### MISSION ROCK LCC ANALYSIS

**SUBMITTAL No.: LCC Buttress  
Plans and Calculations**

**Re: LCC Buttress Earth Pressures  
Mission Rock Phase 1 Development  
San Francisco, California  
Langan Project No. 750604203**

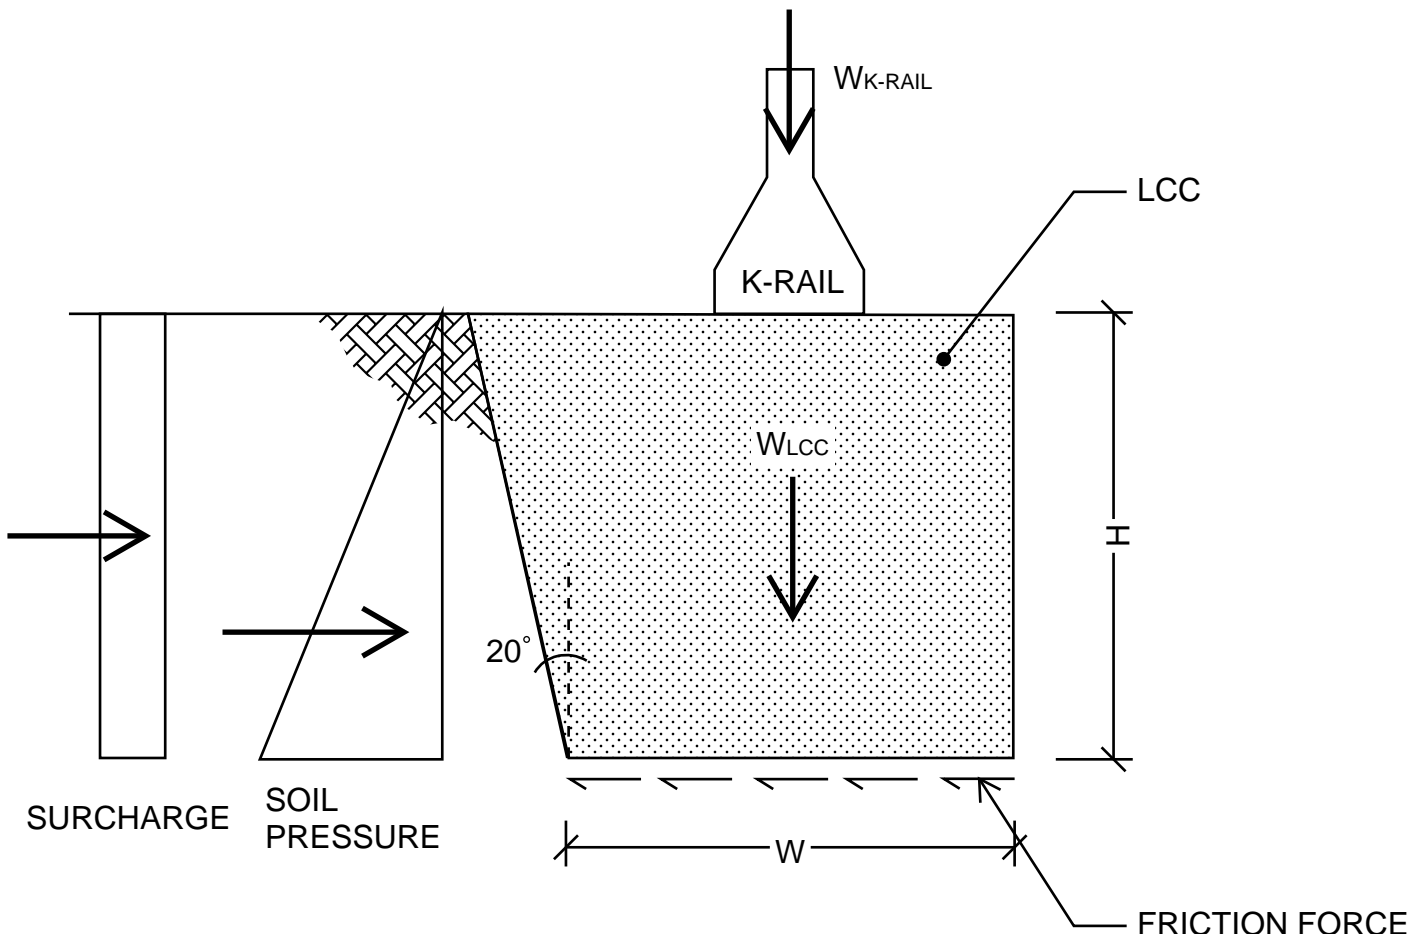
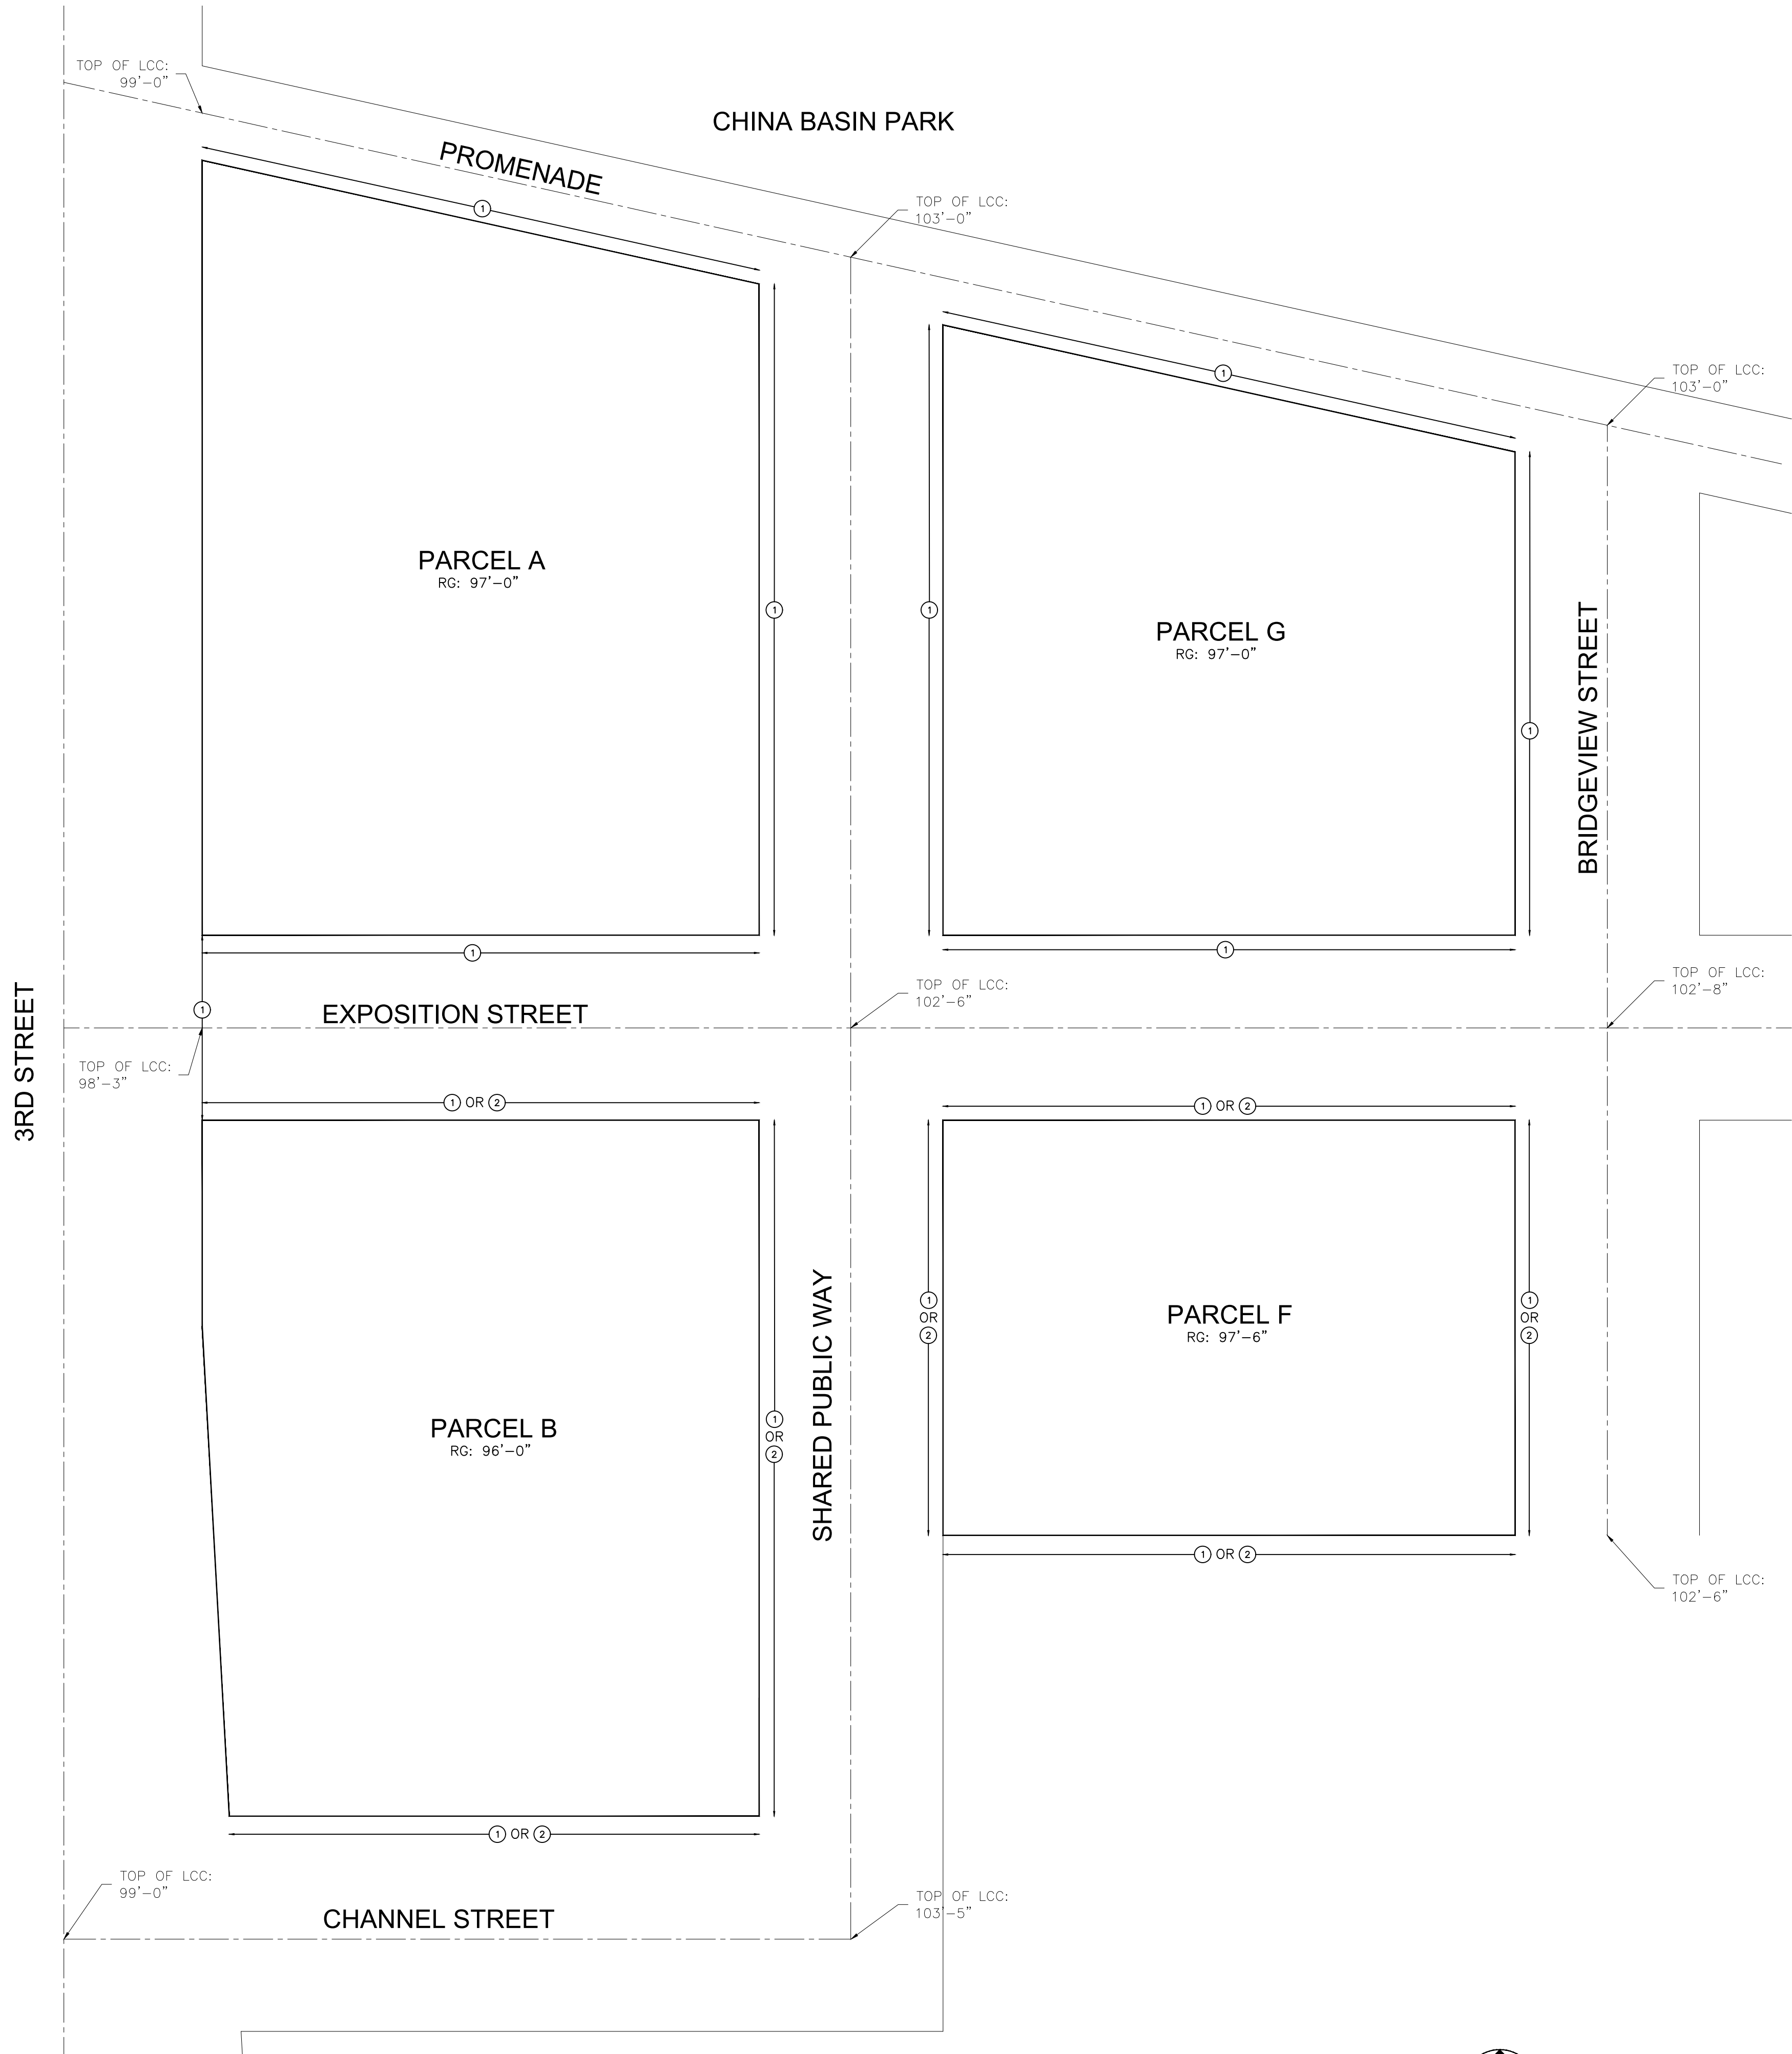
8.5 block is close, but allowable

all have adequate safety factor

SFPW-EST 12-17-20 -  
Sliding safety factors of the LCC gravity wall drop below 1 for most cases without the weight of K-rail. Contractor to coordinate placement of K-rail until the gravity wall incorporated into the LCC roadway.

S-300

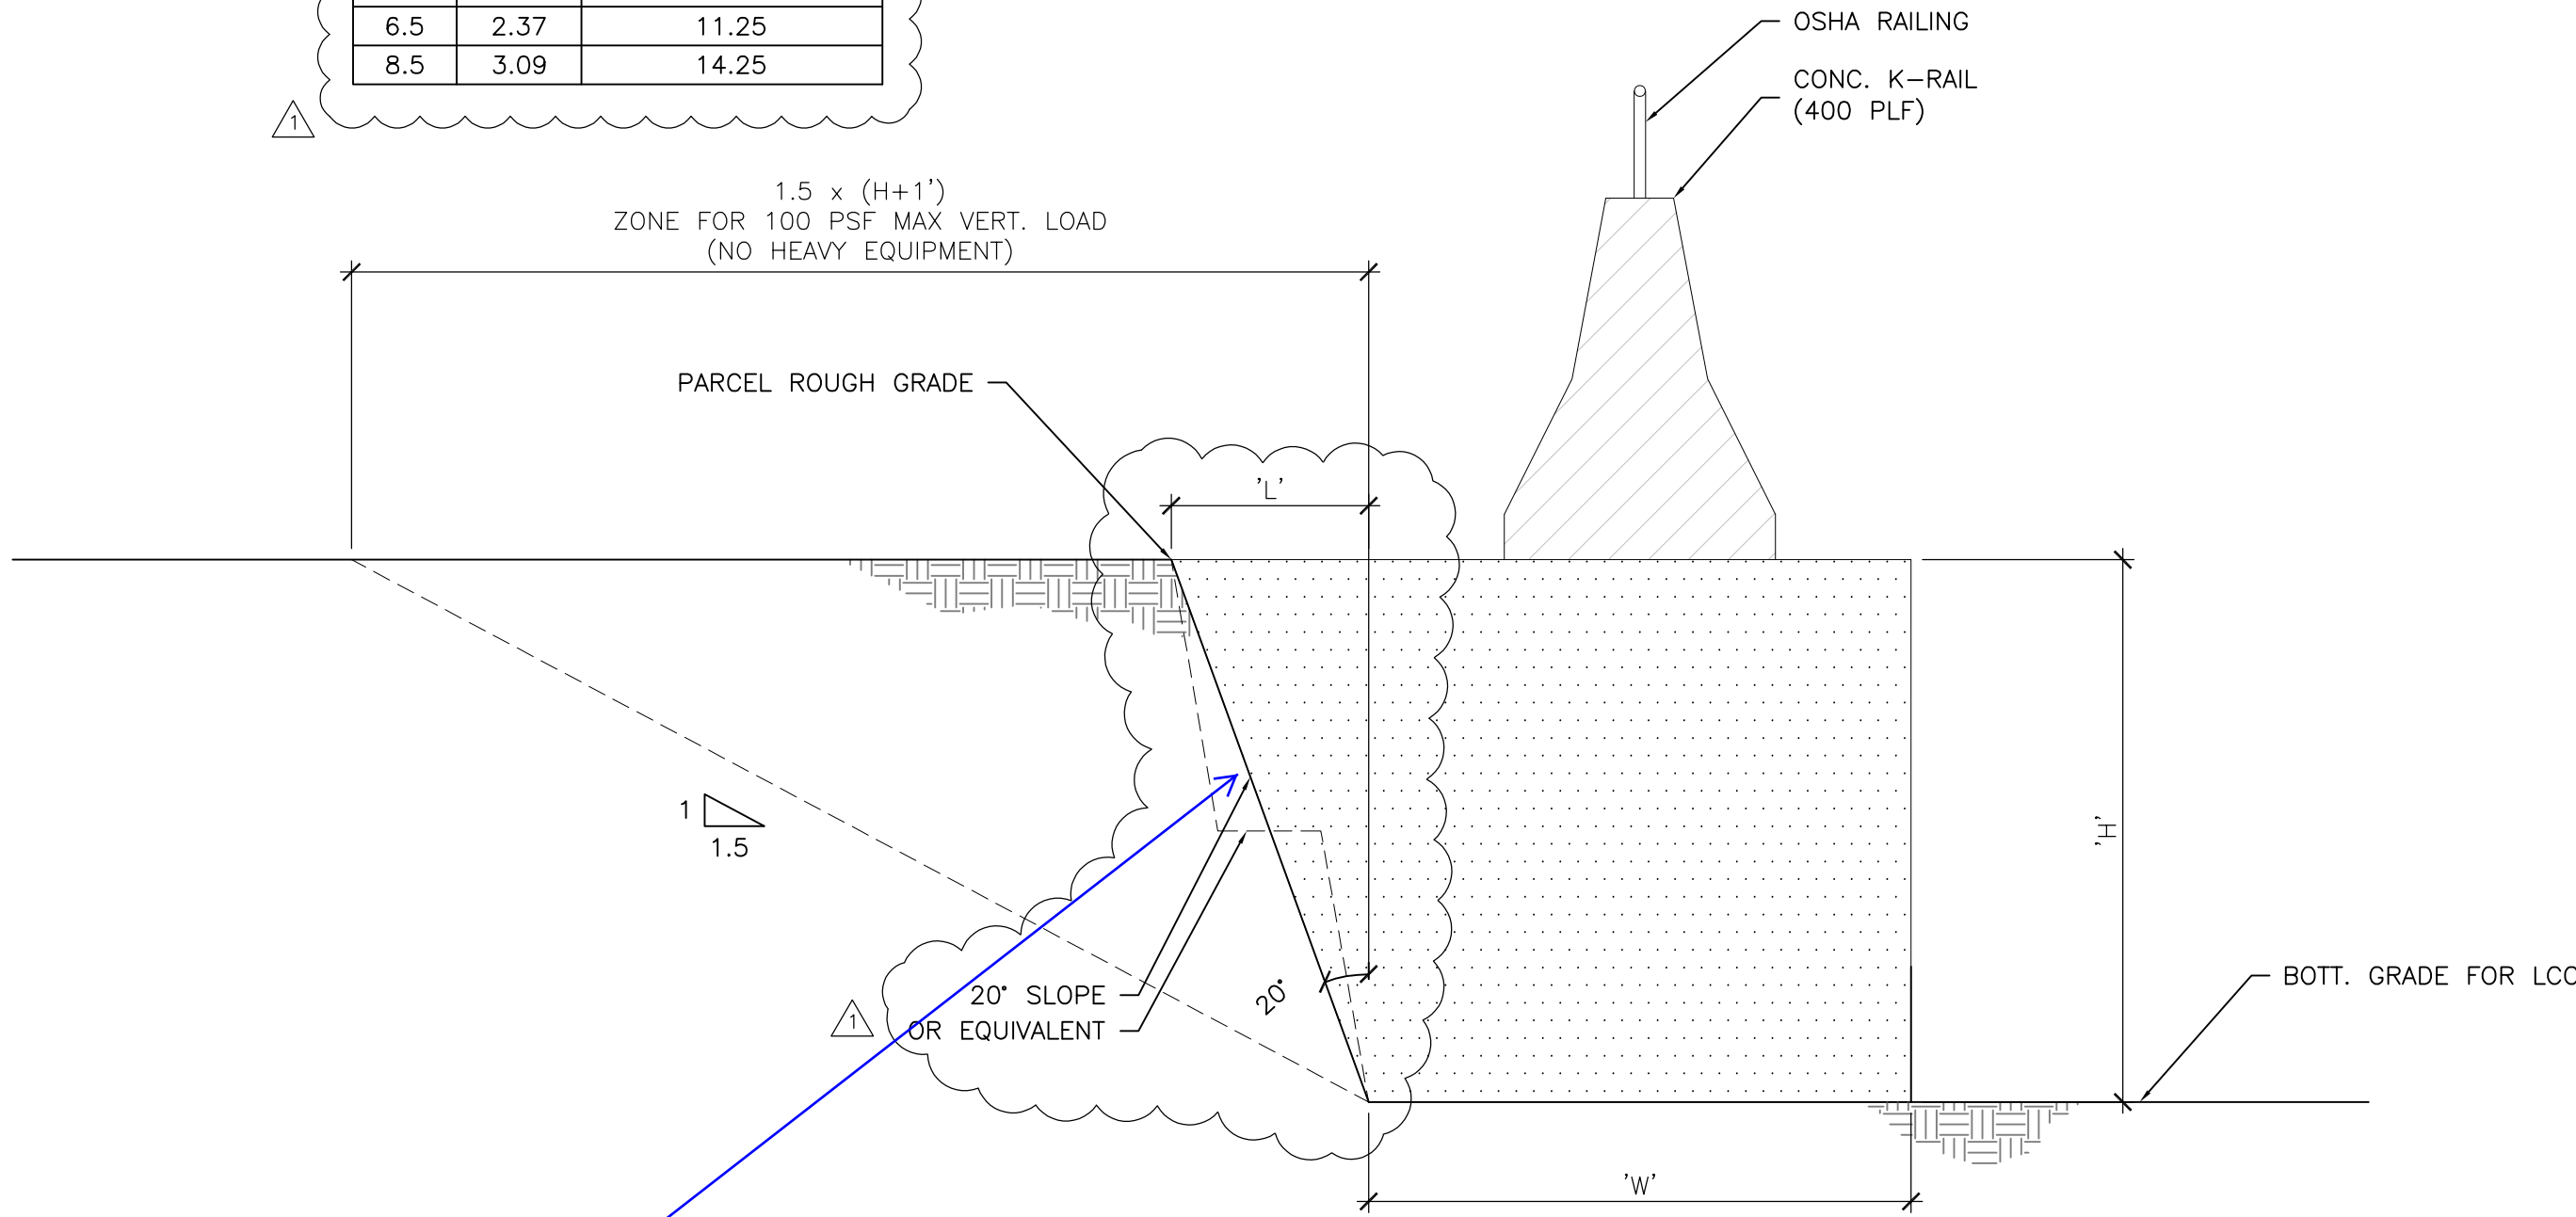
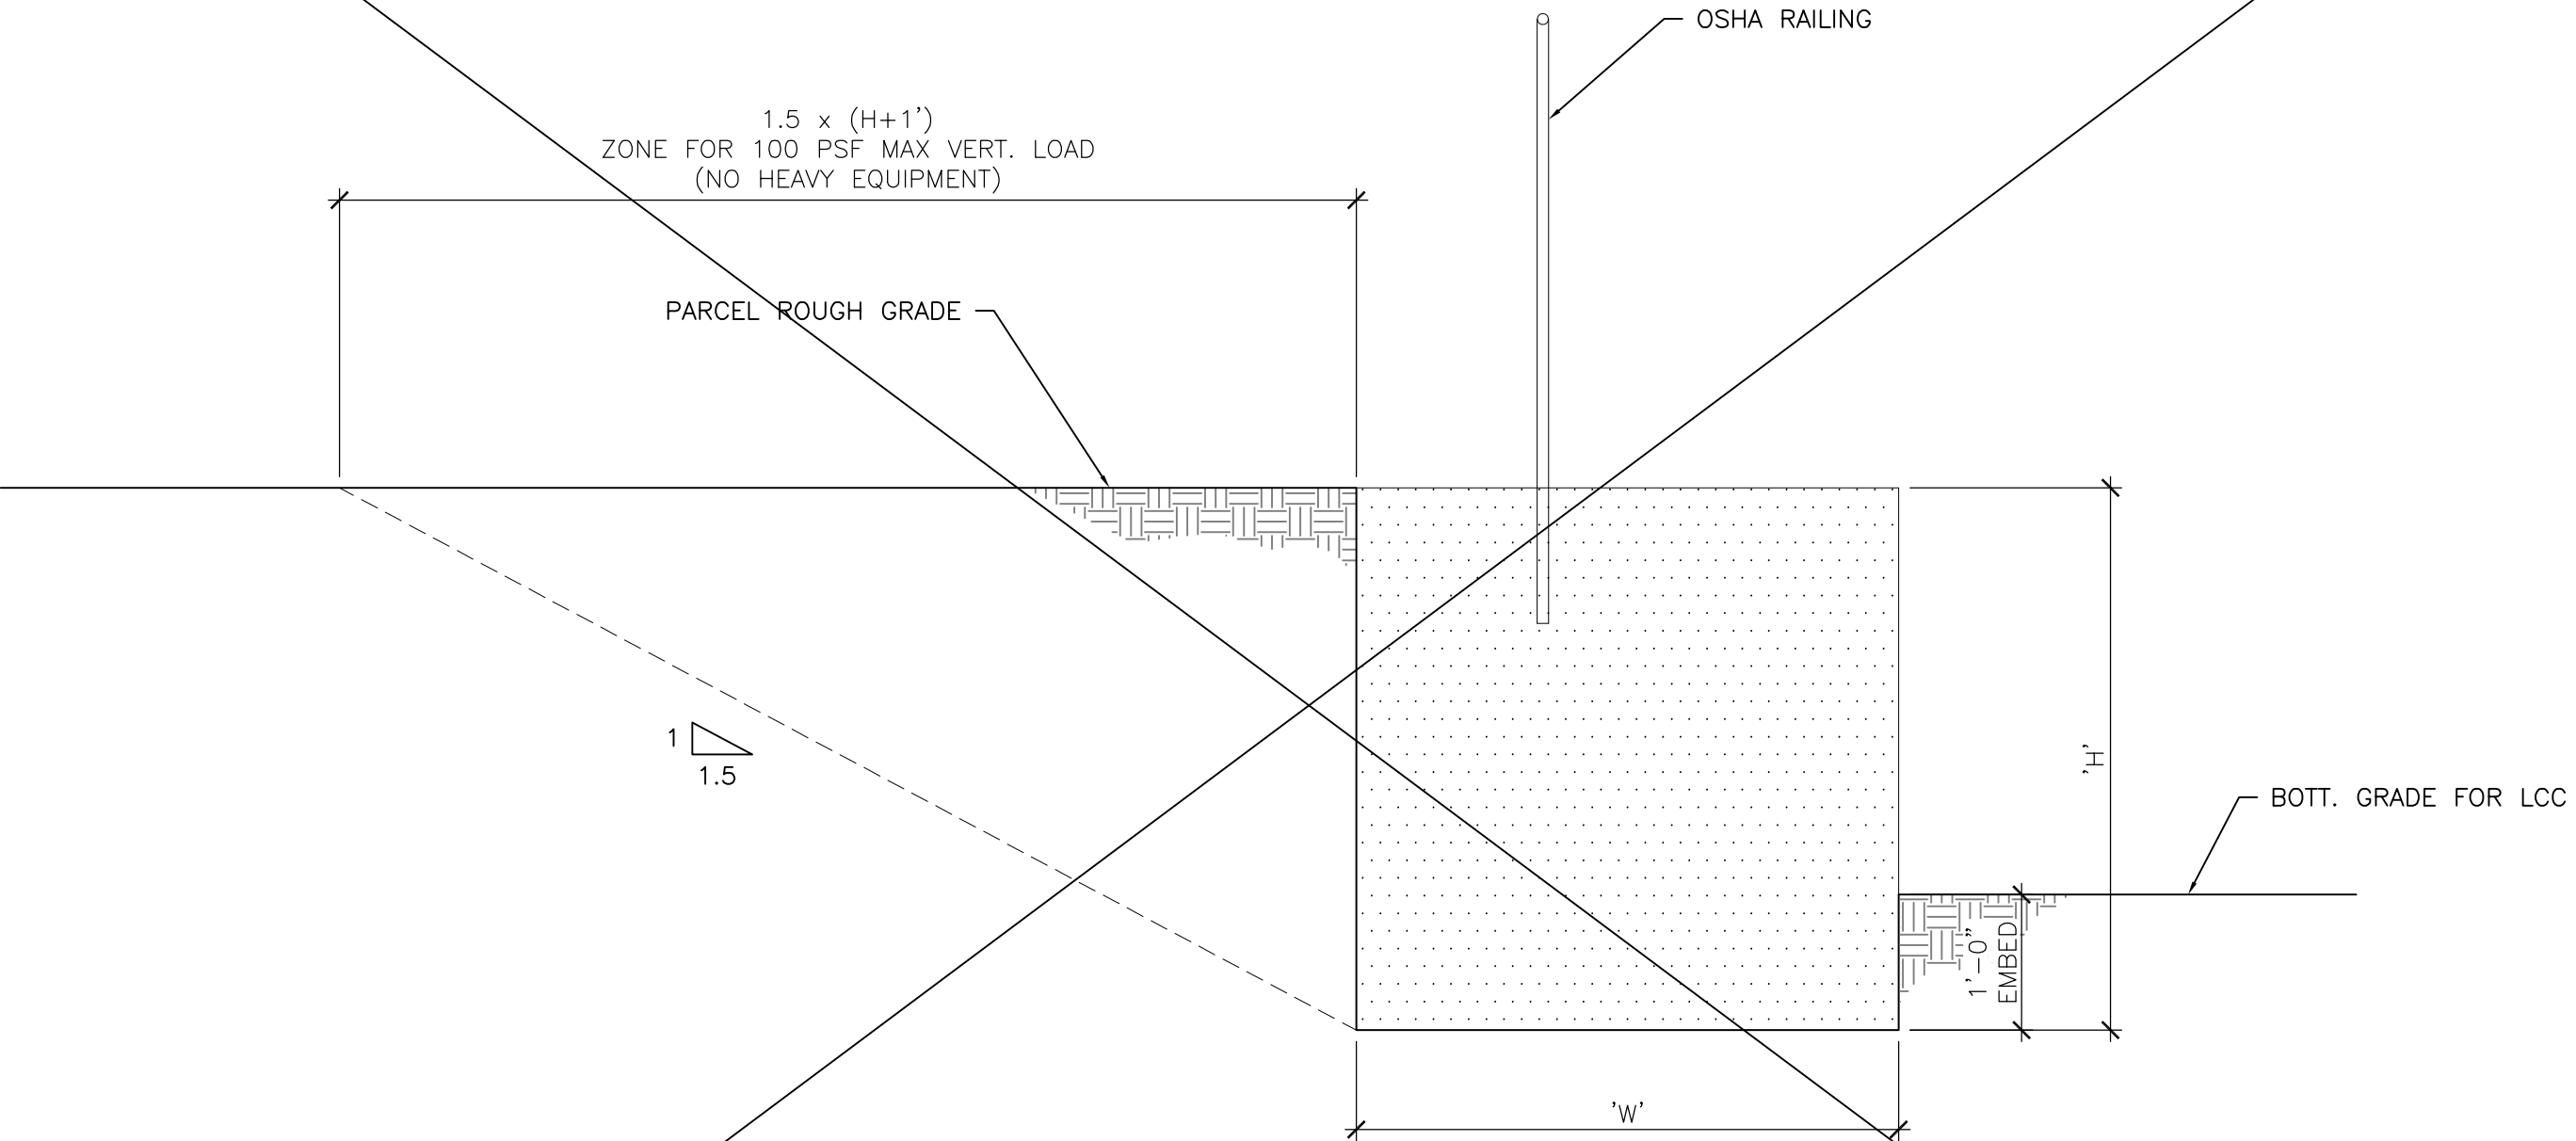
SFPW-EST 12-17-20 -  
Contractor shall verify the  
excavated slope/setback are  
stable prior placement of LCC.

Contractor is reminded of OSHA  
requirement if personnel enter  
the trench.
